Mine Waste Mitigation Plan

Subject: Treasure Hill Development Phase I Environmental Assessment

Treasure Hill Subdivision, Phase 4

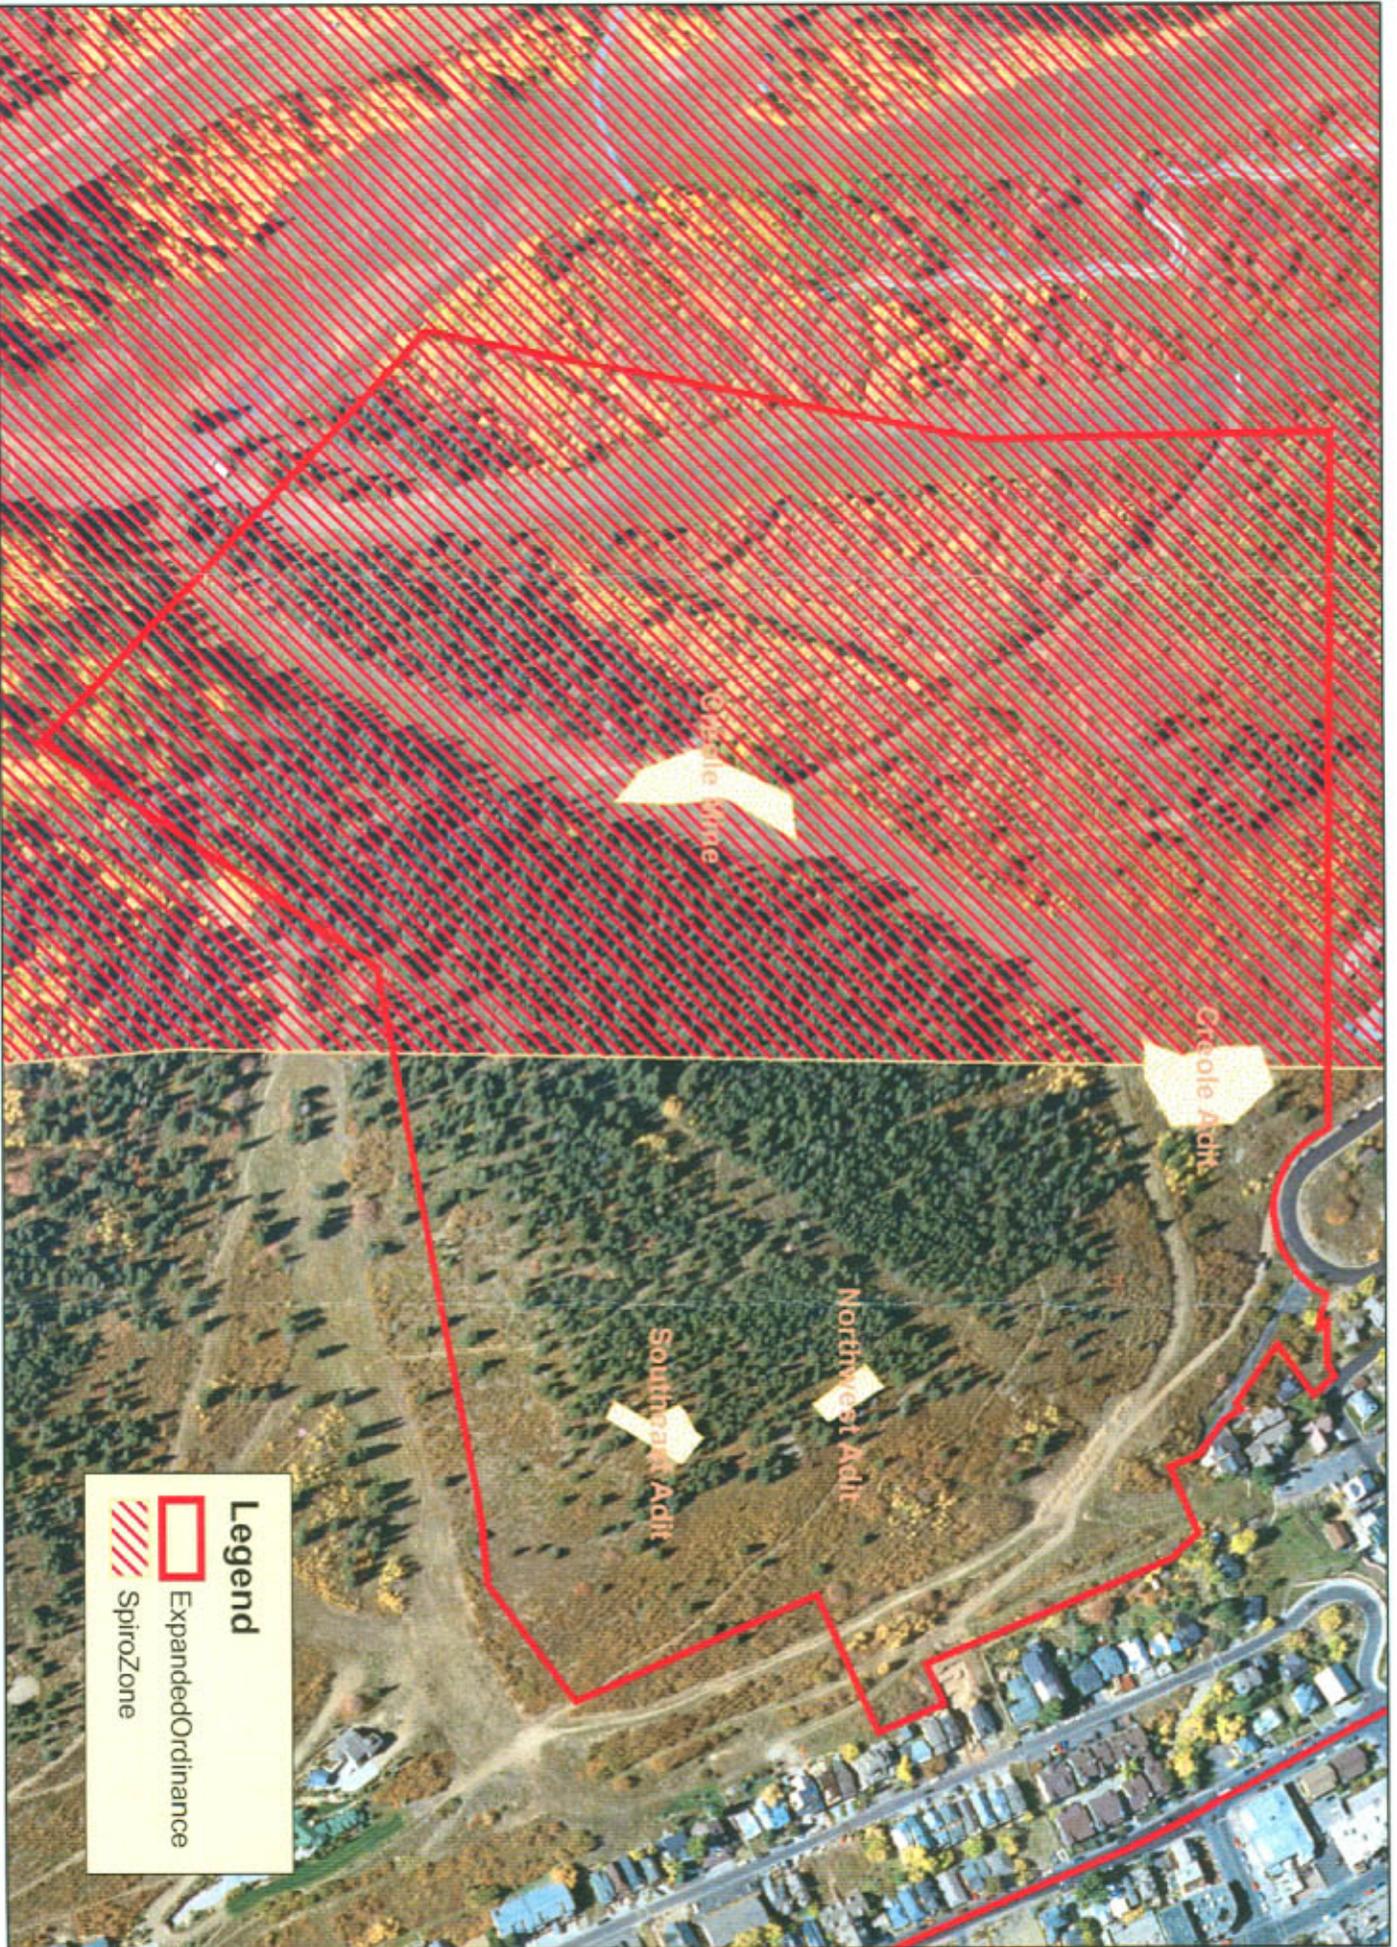
Mentioned in the report was following statement "These mine dumps should be capped in place with clean soil or excavated and capped elsewhere on site in a manner consistent with the guidelines set by PCMC building code". As depicted on the attached map the Treasure Hill Subdivision is situated within PCMC Water Department - Spiro Drinking Water Source Protection Zone. This area is identified within the City's Drinking Water Source Protection Plan which has been adopted and is intended to protect Park City's drinking water sources. The impacted areas identified in the AGEC report have been georeferenced into the City's GIS system and the Creole Mine has been found to be within the zone and the Creole Adit partially within the protection zone. Since the City is required to protect these zones, PCMC will not accept the current contamination associated with mine waste to be left within the protection zone. The Spiro Drinking Water Source Protection recharge Zone has been classified as "vulnerable" due to the numerous faults, drainage channels, aquifer surface exposure, and existing mine shafts and adits. Therefore, leaving the mine waste within this zone is not consistent with the City's goal in protecting this area. As mentioned above, PCMC will await the work plan that defines the chosen strategy for remediating the areas identified within the Phase I report.
